Form 3160-5

DEPARTMENT OF THE INTERIOR BUREAU OF LAND MANAGEMENT						OMB NO. 1004-0135 Expires: July 31, 2010 5. Lease Serial No. NMLC064756		
SUNDRY NOTICES AND REPORTS ON WELLS Do not use this form for proposals to drill or to re-enter an abandoned well. Use form 3160-3 (APD) for such proposals.

1. Type of Well MR Oil Well Gas Well Other				8. Well Name and I WILSON 4	8. Well Name and No. WILSON 4			
Name of Operator					9. API Well No. 30-015-0586	9. API Well No. 30-015-05867-00-S1		
			(include area code 6-3689	e)	10. Field and Pool, N MASON	10. Field and Pool, or Exploratory N MASON

Permanent Abandonment of Federal Wells Conditions of Approval

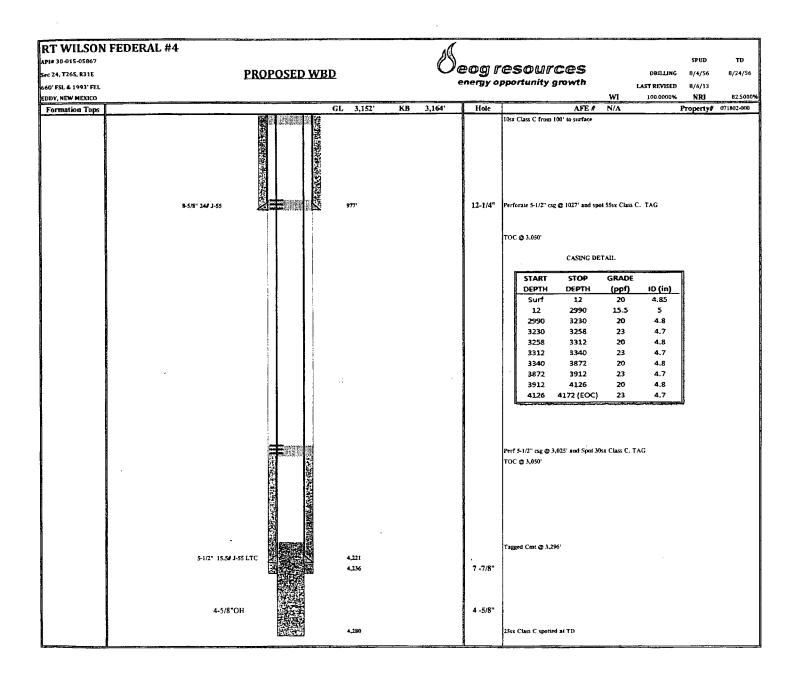
13. Describe Proposed or Completed Op If the proposal is to deepen direction Attach the Bond under which the wo following completion of the involved testing has been completed. Final A determined that the site is ready for f	ally or recomplete horizontally, ork will be performed or provide d operations. If the operation re bandonment Notices shall be fil	, give subsurface the Bond No. or sults in a multipl	locations and meas a file with BLM/BI e completion or rec requirements, inclu	sured and tru IA. Required completion in Iding reclam	e vertical depths of all per I subsequent reports shall n a new interval, a Form ation, have been complete	ertinent ma I be filed w 3160-4 sha	arkers and zones. vithin 30 days all be filed once	
EOG Resources proposes to	P&A this well as follows: ### A2000 PT TO THE PARTY OF T							
TAG existing cement plug a Perforate 5-1/2" casing at 3 Spet 30 sx Class C cement Perforate 5-1/2" casing at 4	3050'. t plug at 3050' シロス	130'plug	, WOC Ta	a. Ad	1. Perf/SOZ	cmt ZZ1	FON 2330-

6. Spot 55 sx Class C cement 6. Spot 10 sx Class C cement 7. Cut off wellhead 3' below s	t plug at 1 027'. WOC min t from 100' to surface. So	nimum 4 hrs. T	AG. SQZ	from	1120-927, WI	pc Ta	7	
on P&A marker. Fill in cellar. 8. Clean and restore location.		RECLAMA	TION PROCES	UIDE	SEE ATTACL	1EU E	:OB
